Access Compliance Report

Public Rights-of-Way

Intersection ID: 52716	Main Street: AGAVA_LN	Cross Street: MAIDENHAIR_CT	Location: NW
ADA ID: C2924C2149A8	Ramp Type: Perp	Initial Pass/Fail: Pass	Overall Compliance: No
Severity Score: 4			
Codes/Mitigation Info/Possible Solution		Field Measurements/Component Compliance

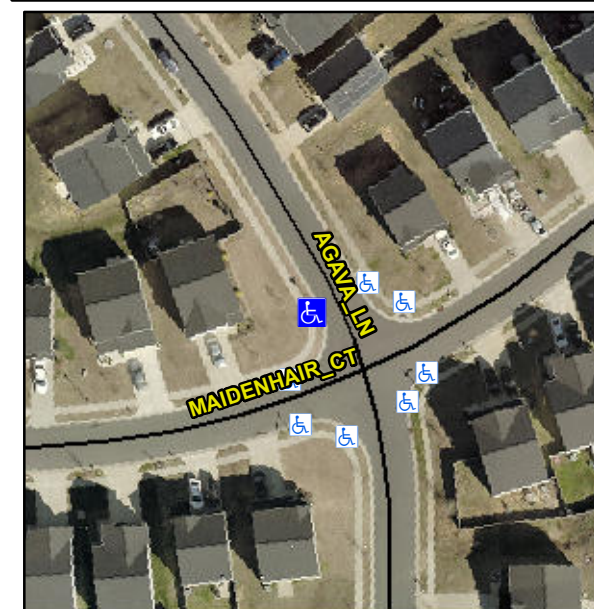
Not Found, R304.2.1, R302.7

Compliance	Description	Data	Compliance	Description	Data
N/A	Ramp Length (in)	48.0	Yes	Ramp Slope (%)	6.2
Yes	Ramp Width (in)	48.0	Yes	Ramp XSlope (%)	1.6
N/A	Flare Type LT	Sloped	N/A	Flare Type RT	N/A
N/A	Flare Slope LT (%)	4.7	N/A	Flare Slope RT (%)	2.6
N/A	Flare Traversable LT?	No	N/A	Flare Traversable RT?	No
No	Landing Length (in)	47.5	Yes	DWS Provided?	Yes
No	Landing Width (in)	45.0	Yes	DWS Contrast?	Yes
Yes	Landing Slope (%)	1.0	Yes	DWS Length (in)	24.0
Yes	Landing X Slope (%)	1.1	Yes	DWS Full Width?	Yes
N/A	Landing Curb? (Y/N)	No	Yes	DWS Offset (in)	1.8
N/A	Shared Landing?	No			
No	Gutter Ponding?	Yes	Yes	Gutter Slope (%)	4.1
Yes	Gutter Lip Ht (in)	0.0	Yes	Gutter X Slope (%)	1.4
N/A	Painted X Walk1?	No	N/A	Painted X Walk2?	N/A
	X Walk 1 Direction	To E		X Walk 2 Direction	N/A
N/A	X Walk 1 Width (in)	N/A	N/A	X Walk 2 Width (in)	N/A
	X Walk 1 Slope (%)	2.1		X Walk 2 Slope (%)	N/A
	X Walk 1 X Slope (%)	2.5		X Walk 2 X Slope (%)	N/A

N/A	Ramp inside XWalk1?	N/A	N/A	Ramp inside XWalk2?	N/A
	Road Slope (%)	N/A	N/A	Clear Space?	Yes
	Road X Slope (%)	N/A	N/A	Clear Space to XWalk (in)	N/A
Yes	Any Obstructions?	No	Yes	Storm Grate/Utility Hazard?	No
	Obstruction Type			Storm Grate/Utility Type	
		N/A			N/A
			Yes	Surface Condition? (G/P)	Good

Remove & Replace Entire Ramp.
